From: Laura Gibbons <Laura.Gibbons@arun.gov.uk>
Sent: 31 August 2021 10:56
To: Planning.Responses <Planning.Responses@arun.gov.uk>
Cc: Michael Eastham <Michael.Eastham@arun.gov.uk>
Subject: WA/63/21/PL- Land East of Tye Lane Walberton BN18 0LU

Engineers Comments Regarding Surface Water Drainage/ Land Drainage

P3	DITCH CROSS-SECTIONS ADDED	SRB	SRB	JEC	20.08.21
P2	ACCESS AMENDED & LONGSECTION ADDED	MJR	JEC	GH	11.06.21
Rev	Description	Drn	Chk	App	Date
ARDENT CONSULTING ENGINEERS					
Third Floor The Hallmark Building 52-56 Leadenhall Street London EC3M 5JE					
Tel: 020 7680 4088 Web: www.ardent-ce.co.uk E-mail: enquiries@ardent-ce.co.uk					
worksafe consultant www.smaiftd.com SSIP SUSSEX SUSSEX SUSSEX					
Client					
VISTRY SOUTH EAST					
Project Title					
LAND EAST OF TYE LANE, WALBERTON					
Drawing Title					
TYE LANE PRELIMINARY SITE ACCESS					
A1 Scale	Date	Designed by			
AS SHOWN	05.11.2020	JEC			
Drawn by	Checked by	Approved by			
JEC	JEC	KM			
Drawing Number	183248-001				Rev
					P3

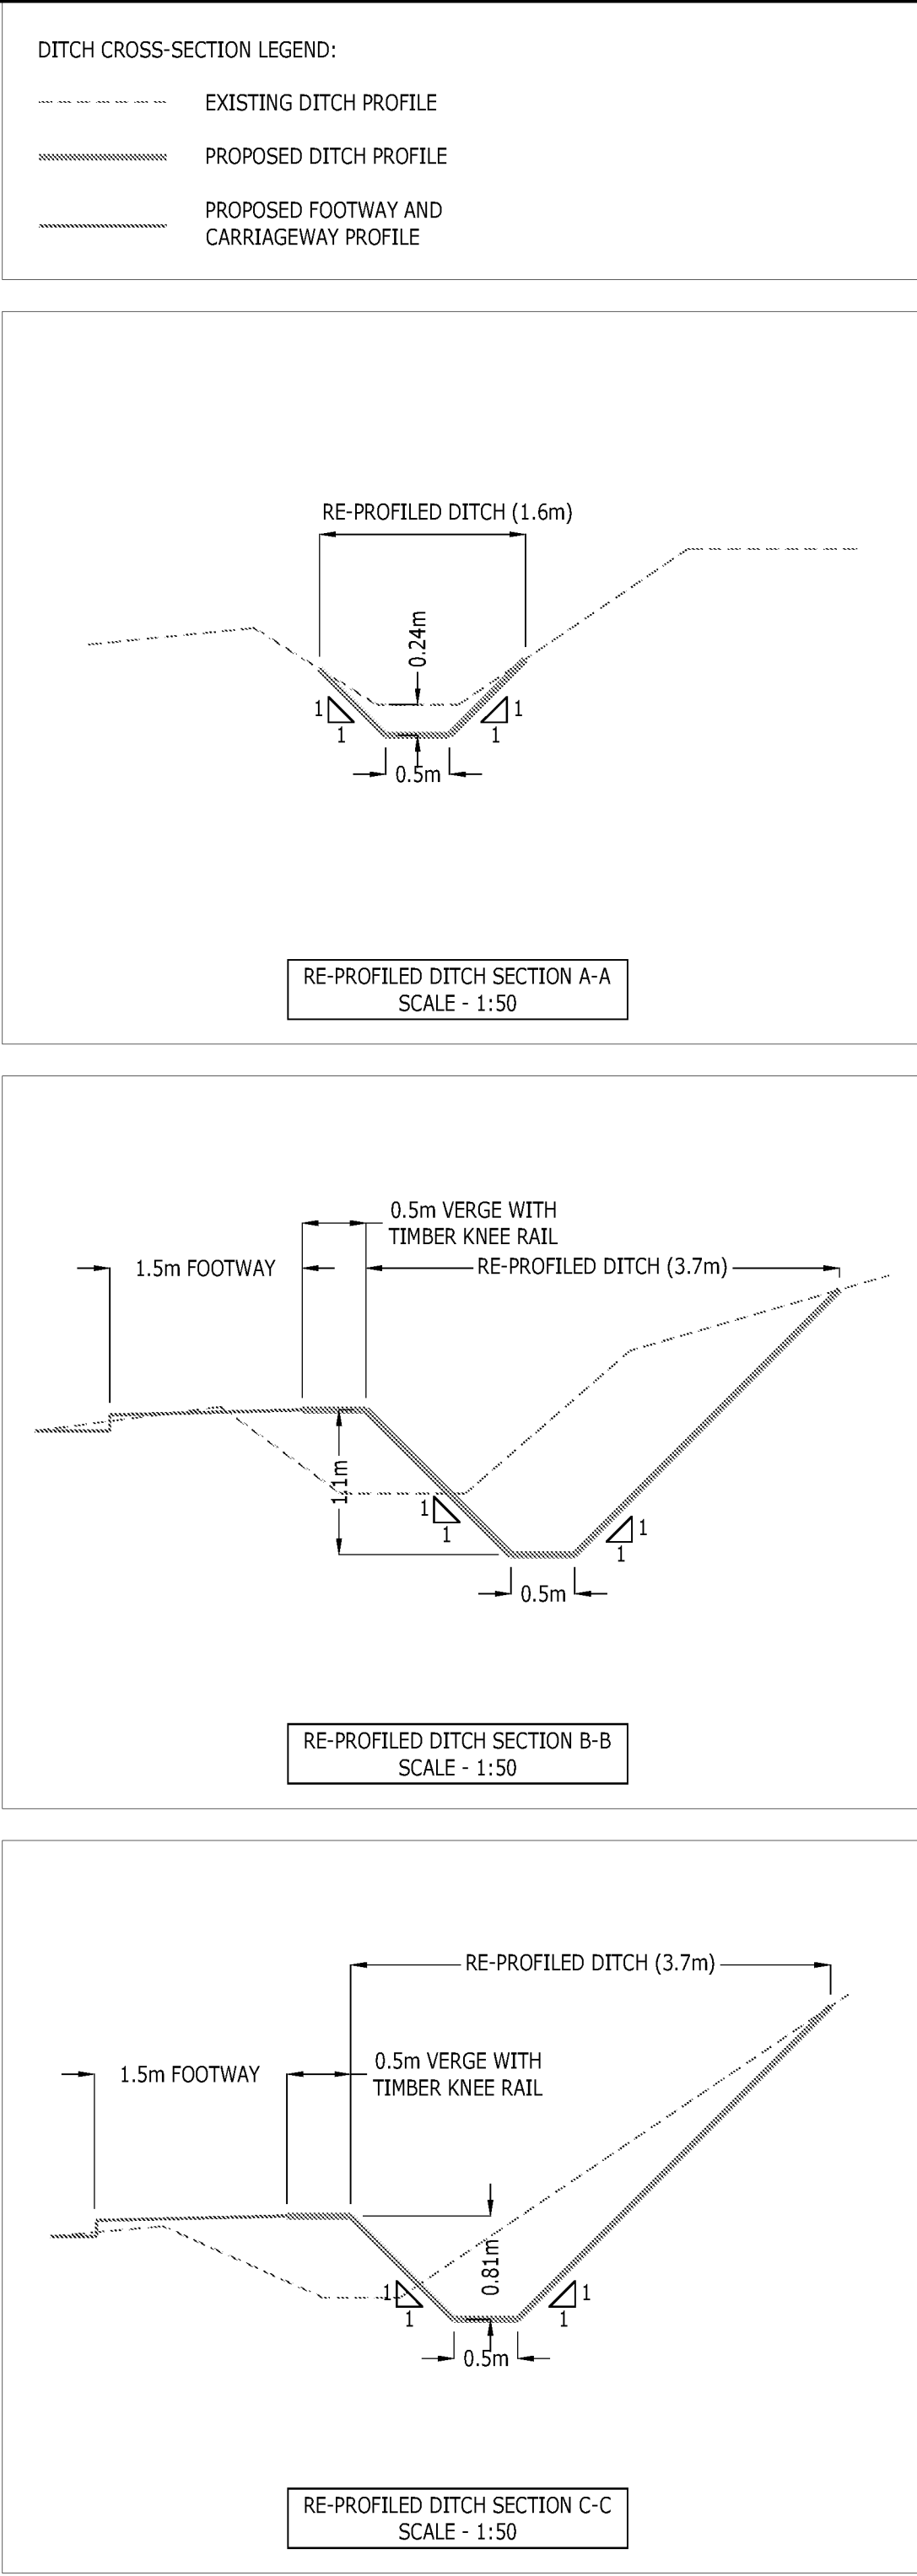
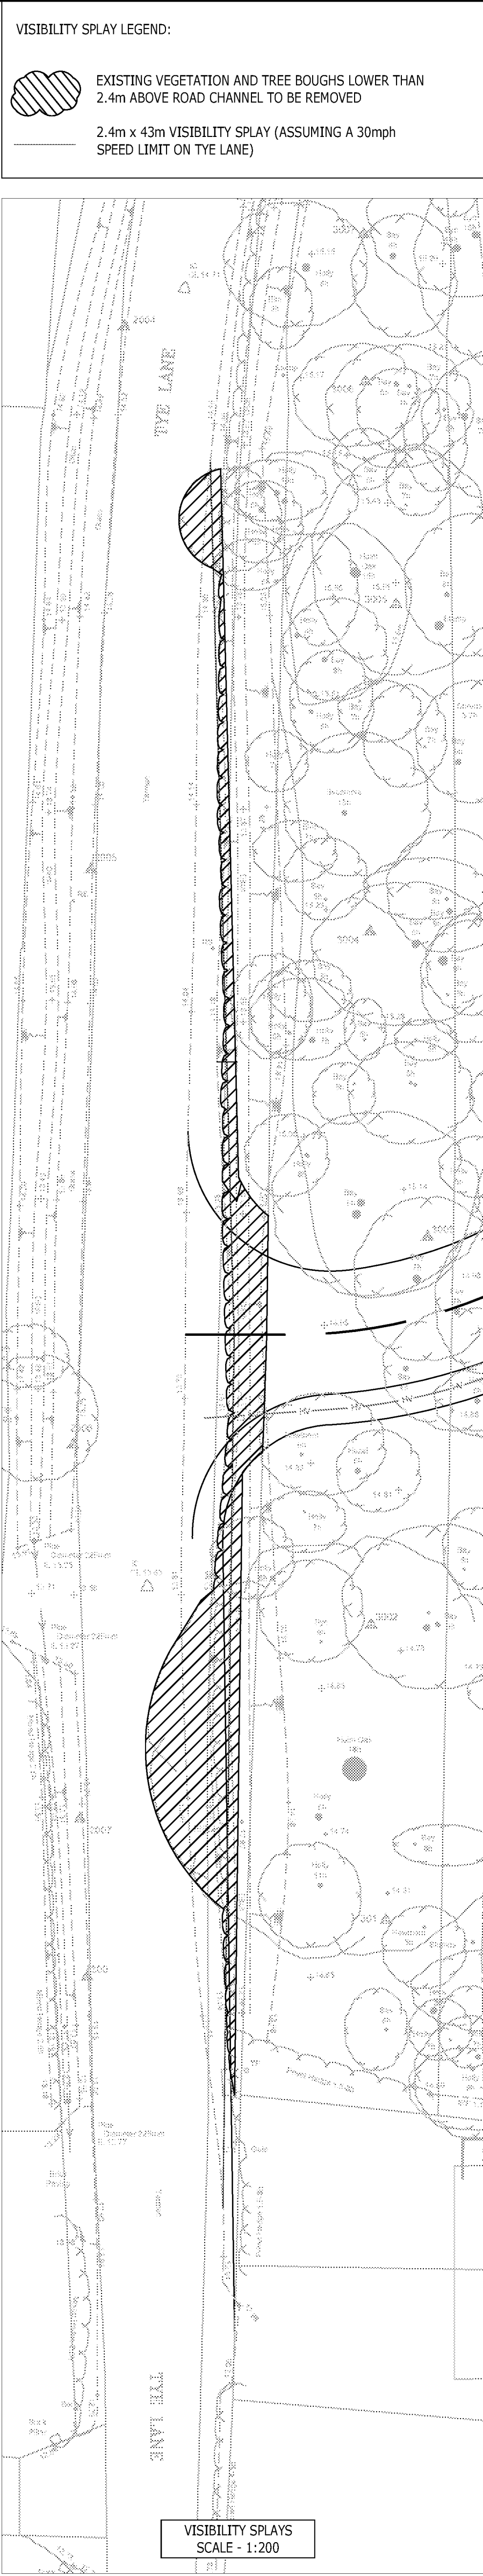
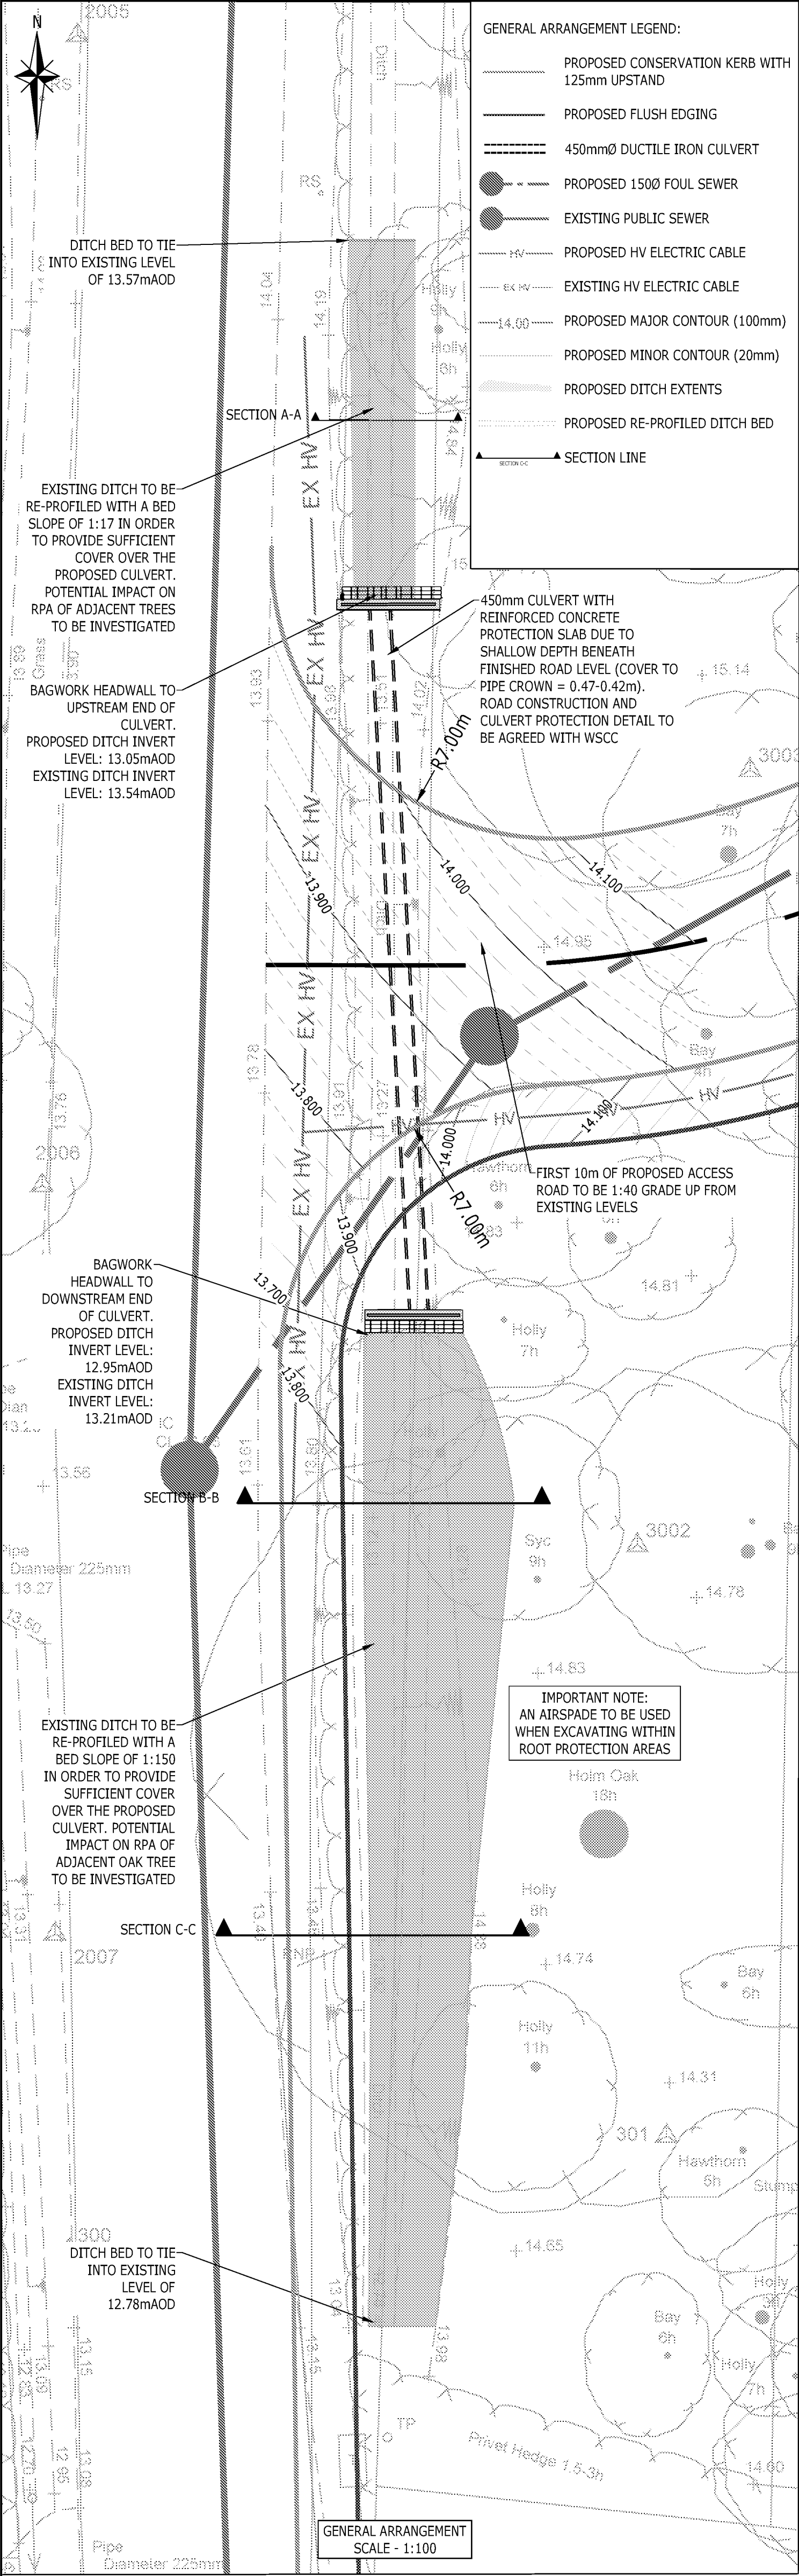
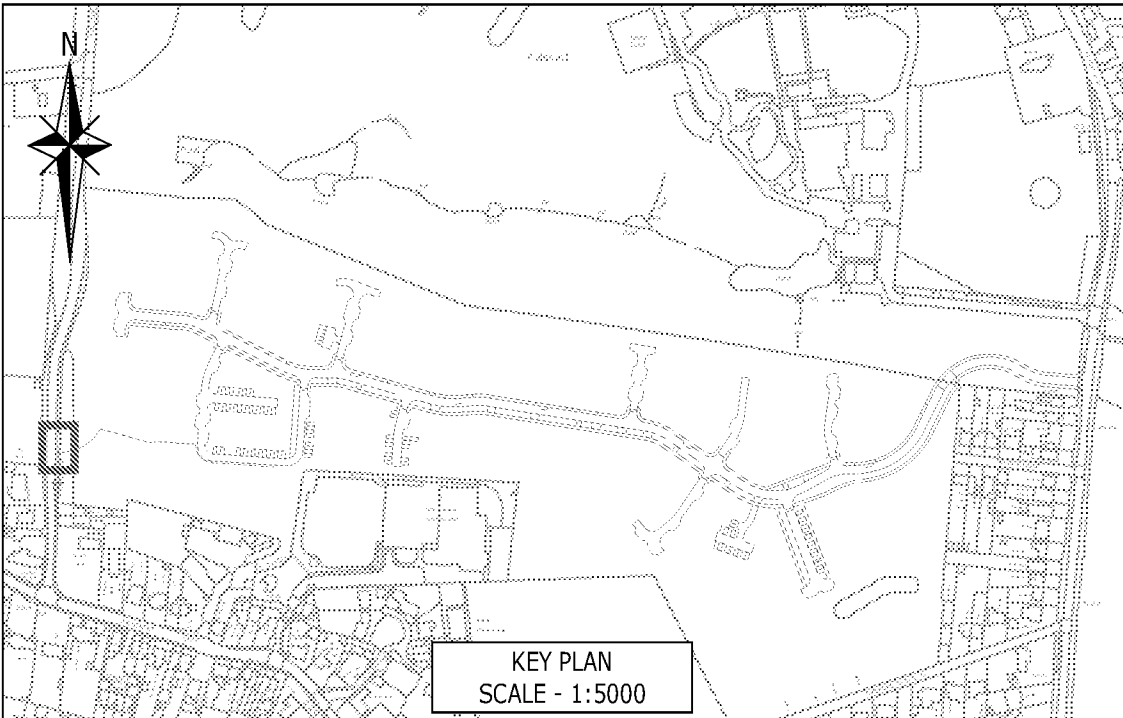
We object to the proposals for the proposed alternative vehicular access off Tye Lane.

Details of proposals for culverting and diverting the watercourse have now been provided, and are attached. We object to the proposals as they currently stand for the following reasons:

1. The new culvert has proposed upstream and downstream invert levels of 13.05 and 12.95 respectively. It is clear that there will be a clash between the proposed culvert and the foul pipe. The foul pipe has an I.L. of 12.8, with a diameter of 150mm, an external diameter of 188mm is typical, therefore this pipe will have a crown level of 12.988. It can be seen this is likely above the invert level of the watercourse culvert at this location, let alone the barrel level of the culvert and base level of the concrete surround. There is clearly a clash.

2. Proposals to provide the longer culvert rely upon deepening the watercourse, it is not clear if this will be possible with the constraints that exist.

3. In order to form a footpath along the east of Tye Lane it is proposed to divert the ditch. The supplied cross sections show:
 - a. The proposed cross sections are narrower than the existing cross sections and will therefore result in a loss of capacity.

- b. The proposed cross sections are proposed to have steep 1:1 banks. These banks are steeper than existing banks, it is unlikely that the proposals will provide a long term stable watercourse. Proposals will likely result in erosion and collapse or a need to engineer banks which could result in a loss of natural habitat.

- c. There is a line of TPO trees along the eastern bank of the watercourse, it is unclear how the new watercourse profile can be provided without damaging these trees.

In summary it has not been evidenced that the new access can be delivered whilst maintaining the free flow of water and capacity within the watercourse.
